ADDENDUM 01

POUND RIDGE FIRE DEPARTMENT FIREHOUSE ADDITIONS & ALTERATIONS

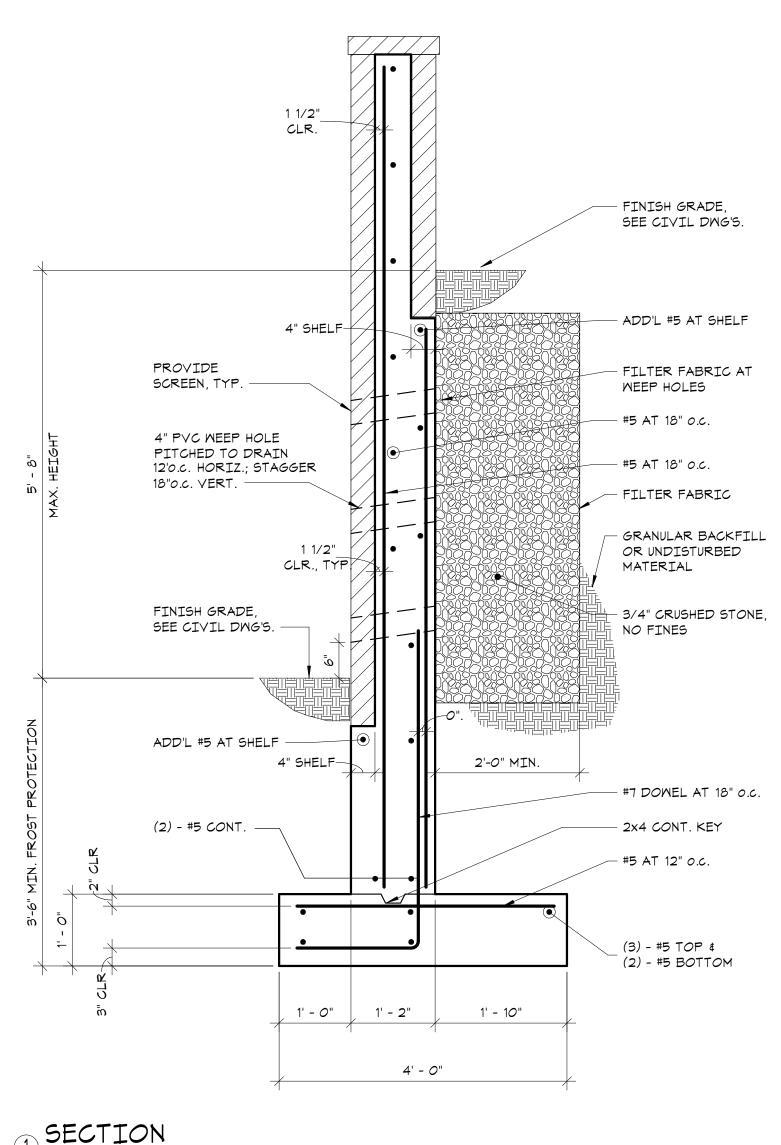
- 1. Add Sketch SSK-01 Section Concrete Retaining Wall
- 2. Add Sketch SSK-02 Section Concrete Retaining Wall

NOTE: DETAIL SUPERSEDES DETAIL 2/S211

55K2

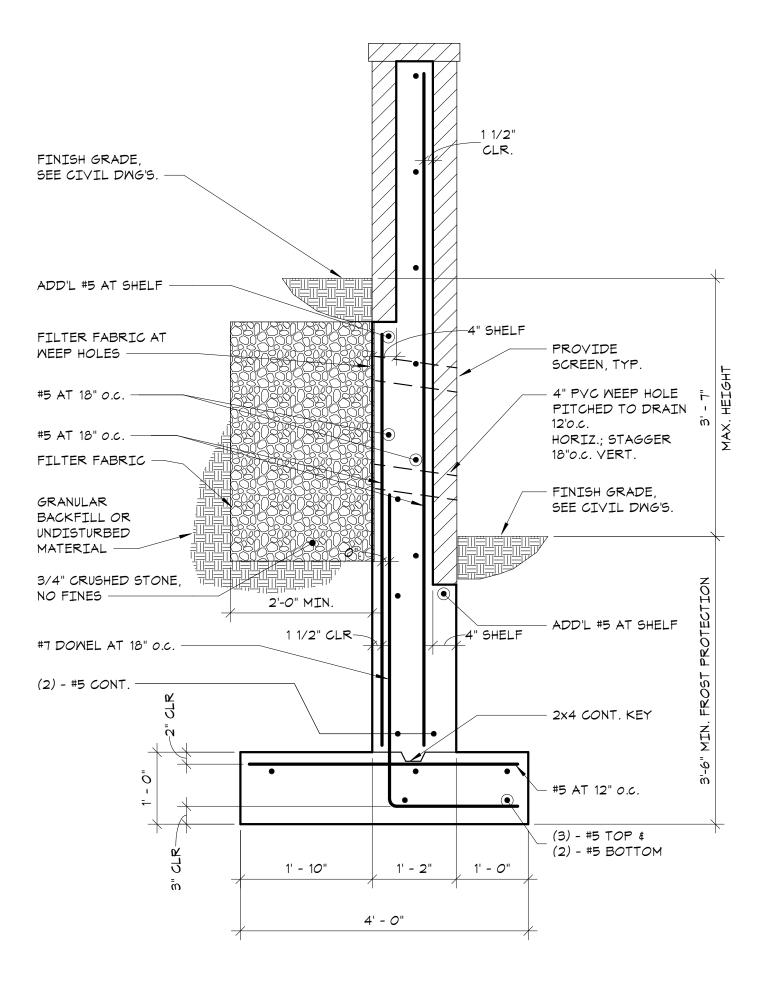
NOTE: DETAIL SUPERSEDES DETAIL 3/S211
